Fire Safety Engineering Design Review for DA Submission

Data Centre Development, Lane Cove West

Date: **28 August 2019**
Document ref: **221518**
Issue No: **V6.0**
Author: **Ho-Yong Tiong/Parkan Behayeddin**

Figure 2.3: L1 Basement Floor Plan

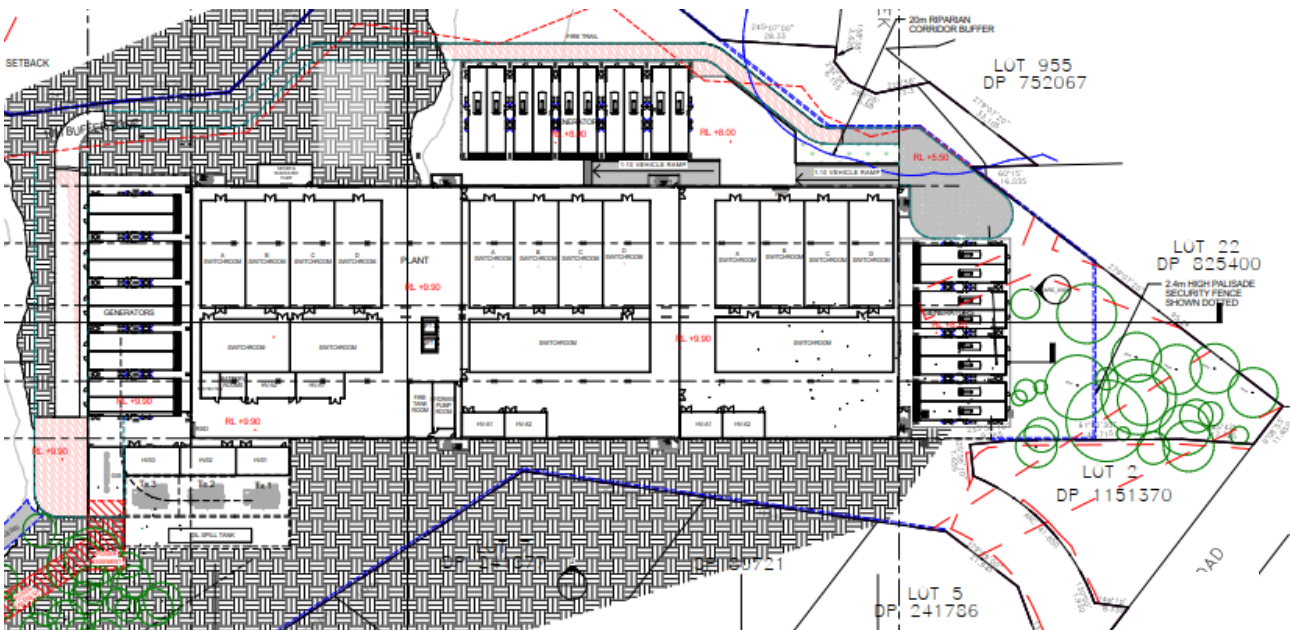
The *Performance Solution* to address the extended travel distance in the basement (L1) plant level shall be evaluated by considering the intermittently occupied nature of the space to demonstrate the generally low risk nature of the L1 plant area. The evaluation shall also consider the fire compartmentation and signage in place to separate plant equipment and fuel storage (i.e. areas containing fuel load) resulting in the majority of the travel path to be located within the circulation/thoroughfare space that will generally be maintained as a sterile and benign environment. Further, the evaluation shall compare the travel distance between the BCA Dts prescribed solution and the proposed solution where the travel path in circulation/thoroughfare space can be considered as a place of relative safety to demonstrate that the travel distance to a place of safety in the propose design is in line with the BCA Dts prescribed travel distance.

6.	<p>It is proposed to permit exit travel distances with the L1 plant room to exceed the maximum distance as prescribed by the deemed to satisfy provisions of the BCA. In this instance, it is proposed to permit travel distances as per the following:</p> <ul style="list-style-type: none"> • Travel distance of 120m between alternative exits in lieu of 60m; and • Travel distance of 80m to nearest exit in lieu of 40m. 	Clause D1.4 & Clause D1.5	DP4 and EP2.2

Figure 2.6: L4 Floor Plan

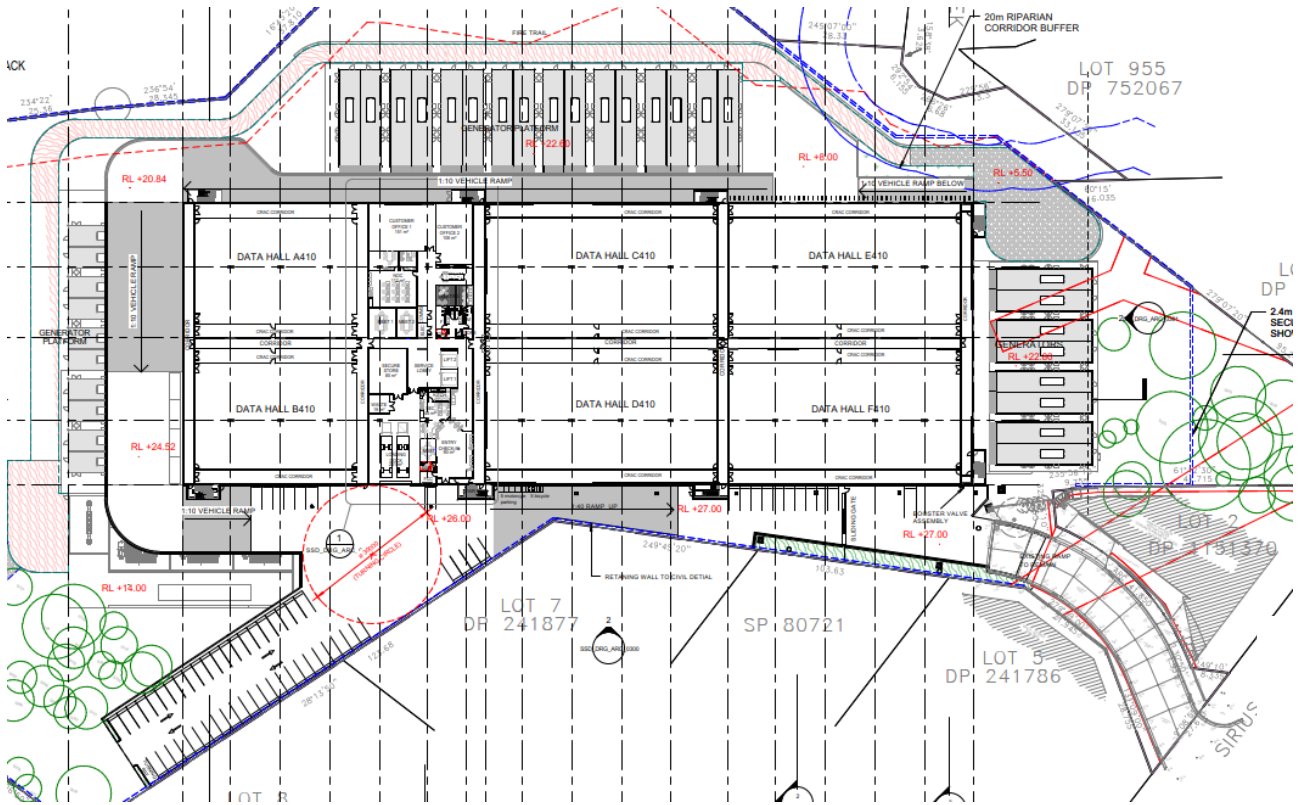
3.	<p>It is proposed to permit exit travel distances within the L4 office building to exceed the maximum distance as prescribed by the deemed to satisfy provisions of the BCA. In this instance, it is proposed to permit travel distances as per the following:</p> <p><u>L4 Office Building:</u></p> <ul style="list-style-type: none"> Travel distance to point of choice of up to 25m in lieu of 20m; and Travel distance to nearest exit of up to 50m in lieu of 40m; and Travel distance between alternative exits of up to 65m in lieu of 60m. 	Clause D1.5	DP4 and EP2.2

Figure 2.8: Roof Plant Layout

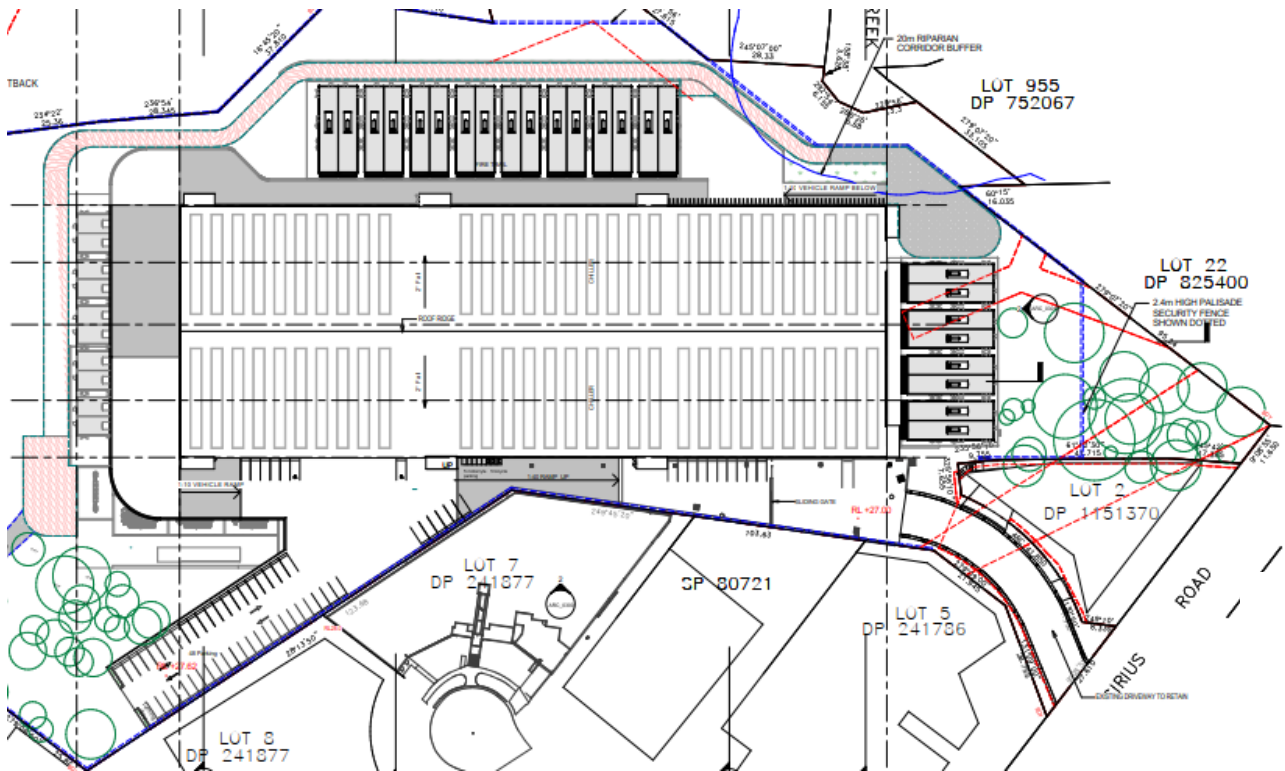
The *Performance Solution* to address the extended travel distance in the roof plan shall be evaluated by considering the area function and use, external nature of the open roof plant, the provision of fire safety measures to assist with early fire notification of occupants and the impact of the extended travel distance on occupant evacuation and fire brigade intervention to demonstrate that occupants in this area can evacuate in line with the Performance Requirements of the BCA.

2.	<p>It is proposed to permit exit travel distances on the open roof plant to exceed the maximum distance as prescribed by the deemed to satisfy provisions of the BCA. In this instance, it is proposed to permit travel distances as per the following:</p> <p><u>Open Roof Plant:</u></p> <ul style="list-style-type: none"> Travel distance to nearest exit is up to 55m in lieu of 40m; and Travel distance between alternative exit is up to 90m in lieu of 60m, measured to horizontal exit. 	Clause D1.4 & Clause D1.5	DP4 & EP2.2
